PROJECT NO.: STBG-0059-02(119)

ADDENDUM

Bridge Repair on 13th Avenue over I-59 (Bridge No. 93.9), known as Federal Aid Project No. STBG-0059-02(119) / 109299301 in Jones County.

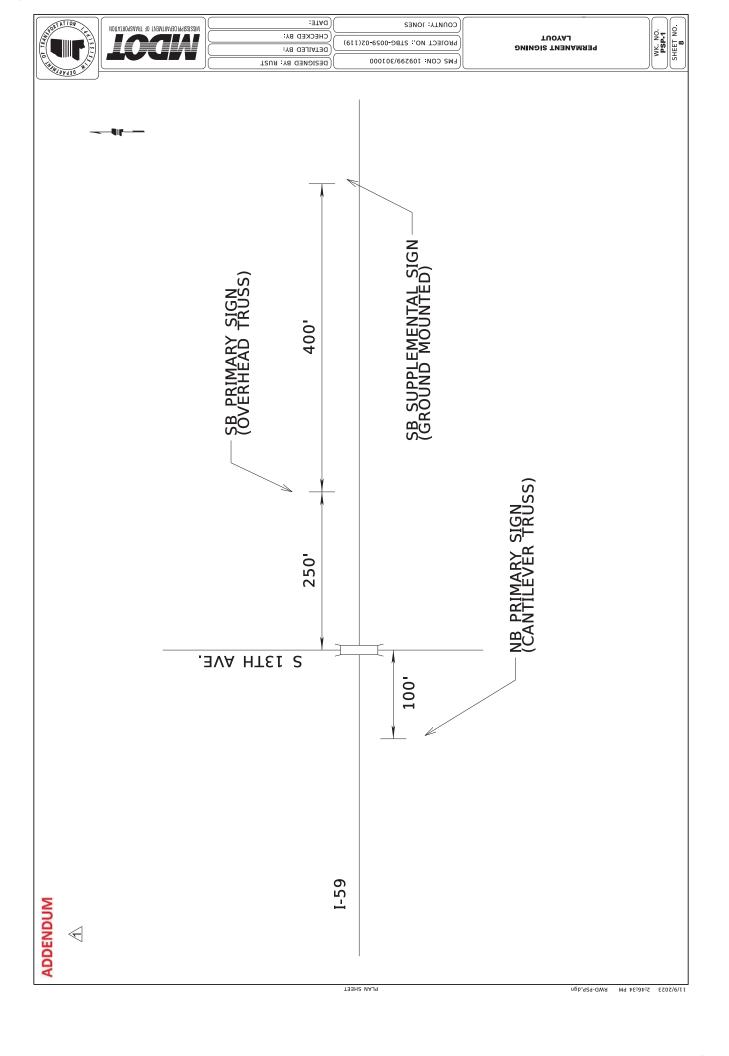
CONTROL ON THE CONTRO	FMS CON. # 109299-301000	REVISIONS	SHEET NO. BY	2,3,5,8,9,10,11,12 SR		
	FMS CON. # 1		DATE	11/09/23 2,3,5

DATE 1st ORDER ADDENDUM 2nd ORD 11/9/23 X X 11/9/23 X X	ORDER BY	WK. NO. DI-1	ADDED STANDARD FOR GROUND MOUNTED SIGNS
	S S		ADDED STANDARD FOR GROUND MOUNTED SIGNS
	SR		ADMISTED SIGN CHANTITY APPED BAY ITEMS
			ADJUSTED SIGN QUANTITY, ADDED PATTIENS
	SR	PSP-1	ADDED SHEET
	SR	PSP-2	ADJUSTED PAGE NUMBER & DESCRIPTION
	SR	PSP-3	ADJUSTED PAGE NUMBER & DESCRIPTION
	SR	PSP-4	ADDED SHEET
x X X	SR	0Н-1	АРДЕД SHEET
